CITY OF ALBUQUERQUE

Re: HUYHN
5609 Paradise Blvd NW 87114
Traffic Circulation Layout
Engineer's/Architect's Stamp ??-??-?? (B11D012)

Based upon the information provided in your submittal received 09-04-2019, the above referenced plan cannot be approved for Building Permit until the following comments are addressed:

A
A100
SITE PLAN
1" = 30'-0"

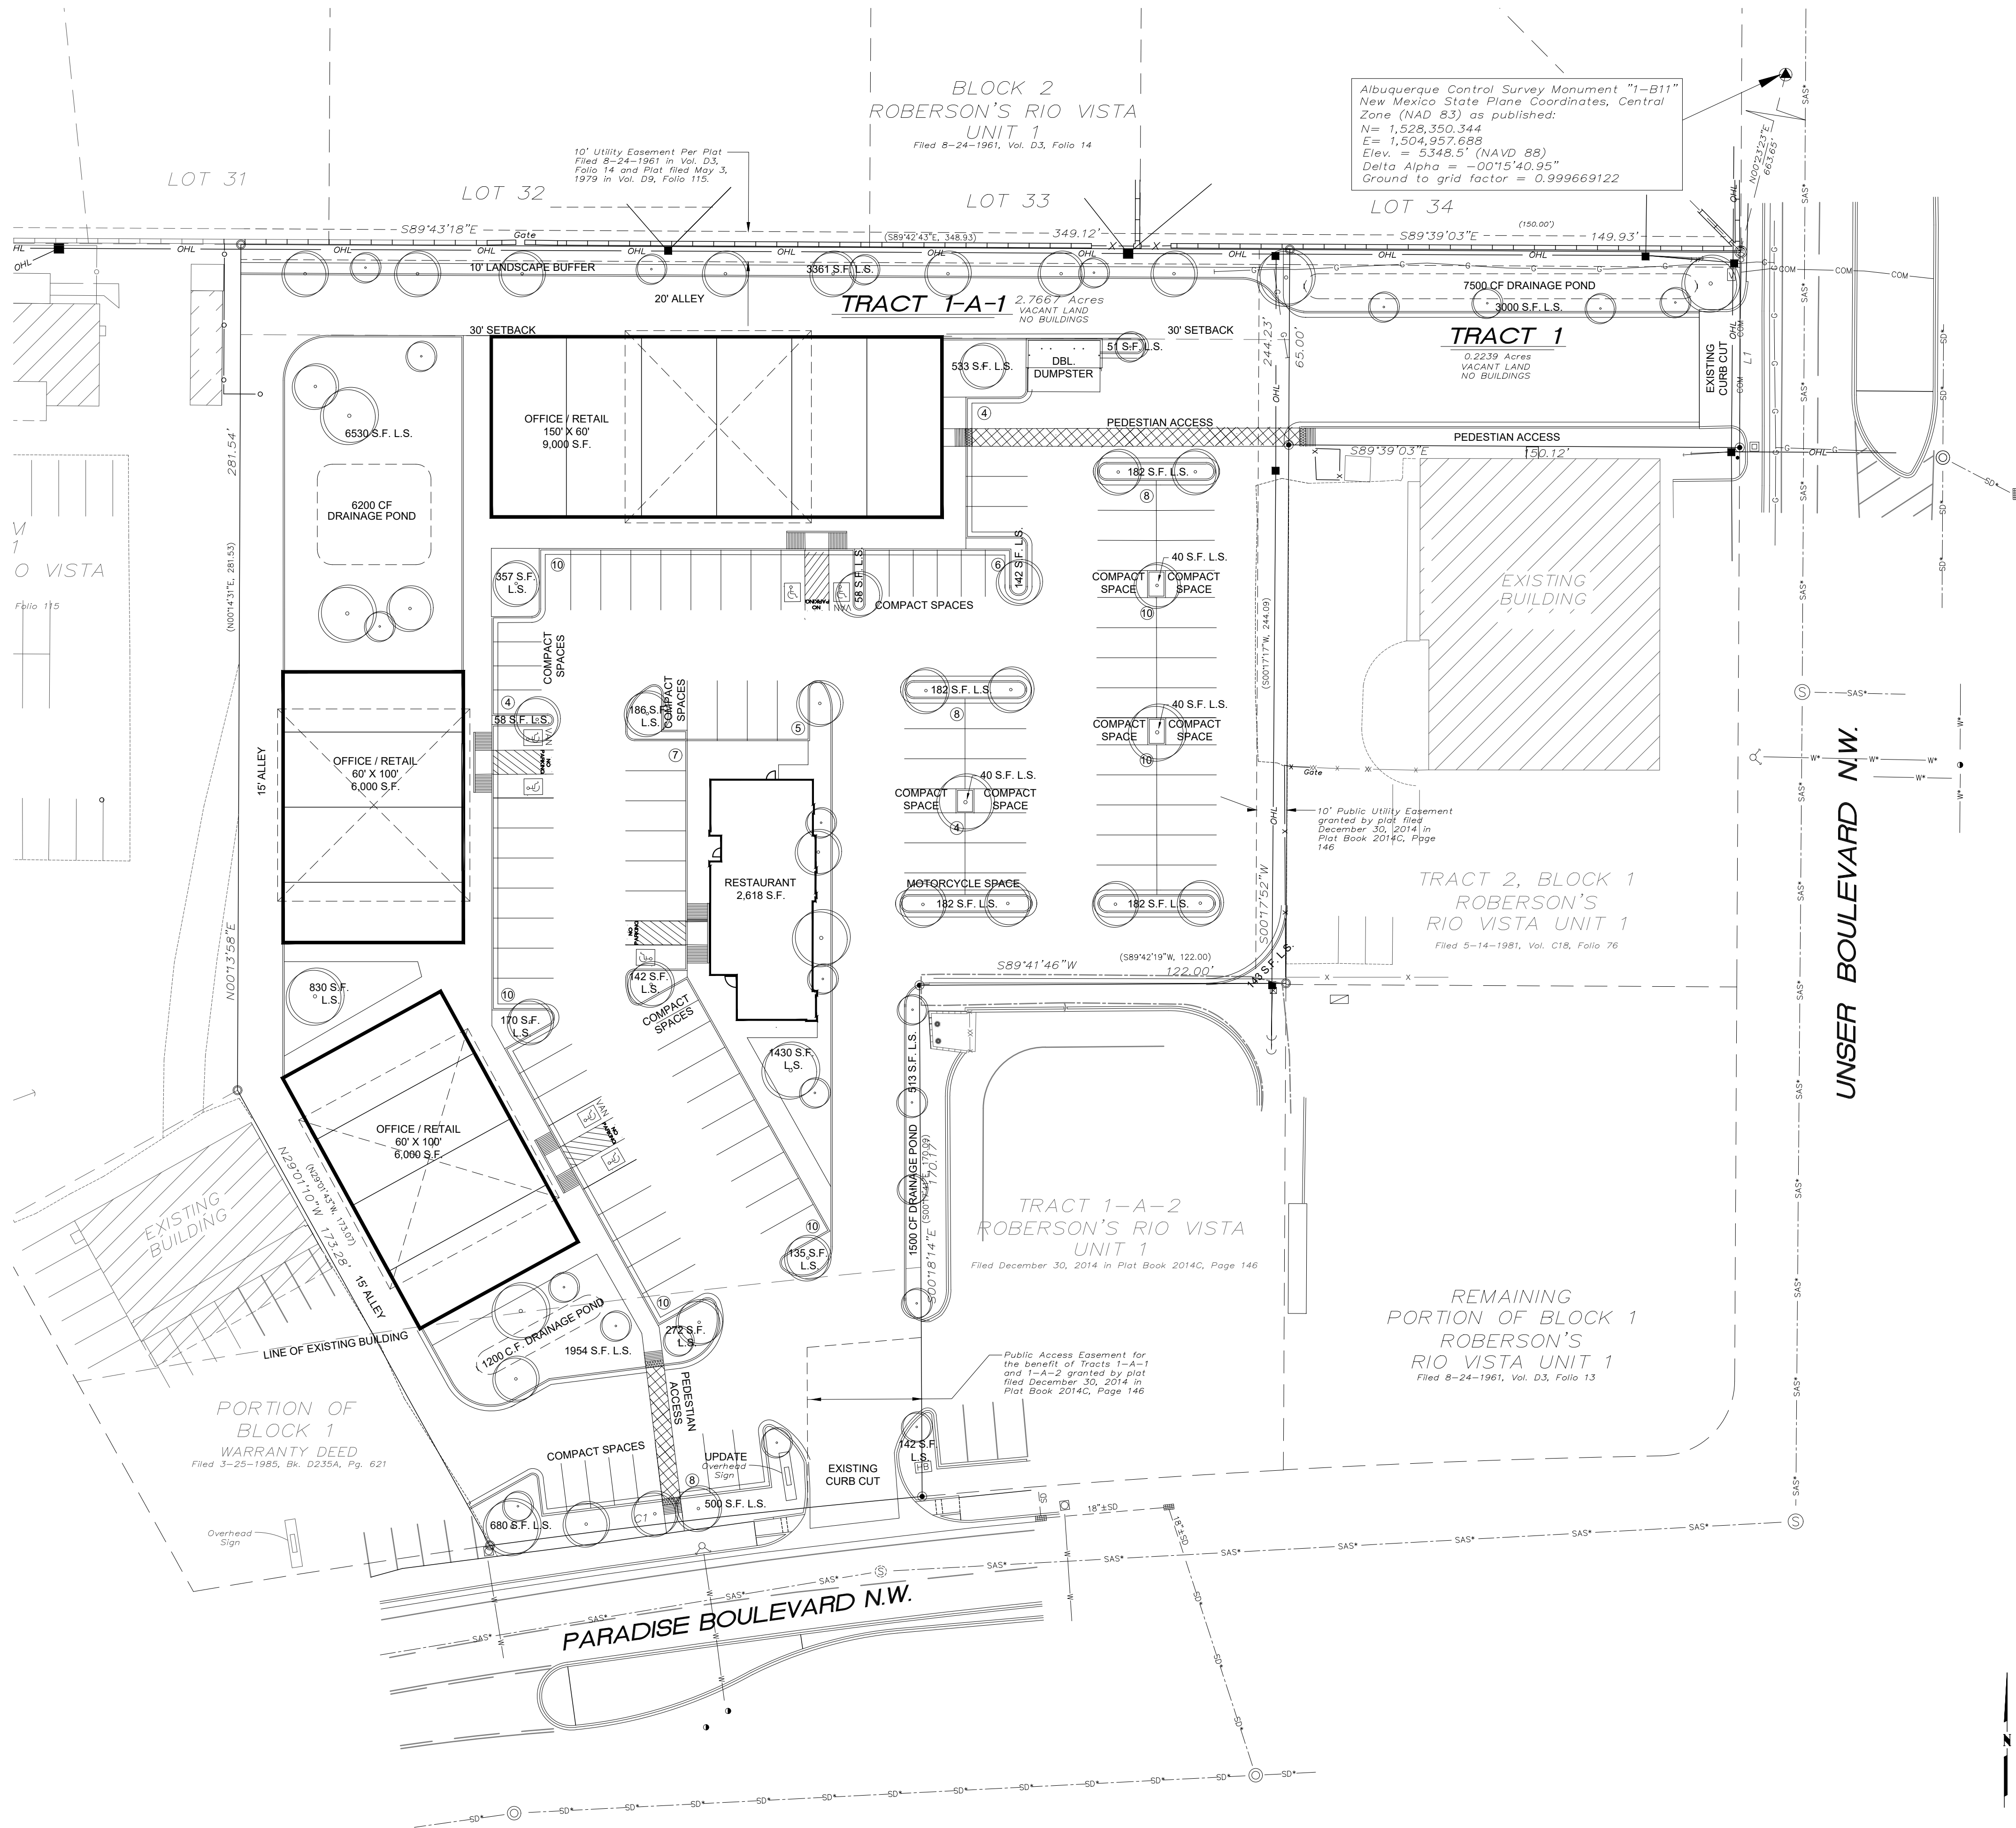
1. The traffic circulation layout must be stamped, **signed, and dated** by an engineer or architect licensed in the state of New Mexico.
2. Label the compact parking spaces by placing the words "**COMPACT**" on the pavement of each space.

3. The ADA accessible parking sign must have the required language per 66-7-352.4C NMSA 1978 "**Violators Are Subject to a Fine and/or Towing.**" Please call out detail and location of signs.

4. ADA curb ramps must be updated to current standards and have truncated domes installed.
5. Motorcycle parking spaces shall be designated by its own conspicuously posted upright sign, either free-standing or wall mounted per the zoning code.

6. All bicycle racks shall be designed according to the following guidelines:
 - a. The rack shall be a minimum 30 inches tall and 18 inches wide.
 - b. The bicycle frame shall be supported horizontally at two or more places. Comb/toaster racks are not allowed.

- c. The rack shall be designed to support the bicycle in an upright position. See the IDO for additional information.
 - d. The rack allows varying bicycle frame sizes and styles to be attached.

- e. The user is not required to lift the bicycle onto the bicycle rack.
 - f. Each bicycle parking space is accessible without moving another bicycle.

7. Bicycle racks shall be sturdy and anchored to a concrete pad.

8. A 1-foot clear zone around the bicycle parking stall shall be provided.
9. Bicycle parking spaces shall be at least 6 feet long and 2 feet wide.
10. Show all drive aisle widths and radii. Some dimensions are not shown.
11. The minimum drive aisle dimensions are shown below

12. Refuse vehicle maneuvering shall be contained on-site. The refuse vehicle shall not back into the public right of way.; provide a copy of refuse approval.
13. It is not apparent what type of pavement surface is being proposed. A hard driving surface will be required as part of this proposed project for parking area and drive aisles.
14. Shared Site access: driveways that straddle property lines, or are entirely on one property but are to be used by another property, shall have an access easement. Please include a copy of your shared access agreement with the adjacent property owner. This applies to TRACT 1 at the north east corner of the property.
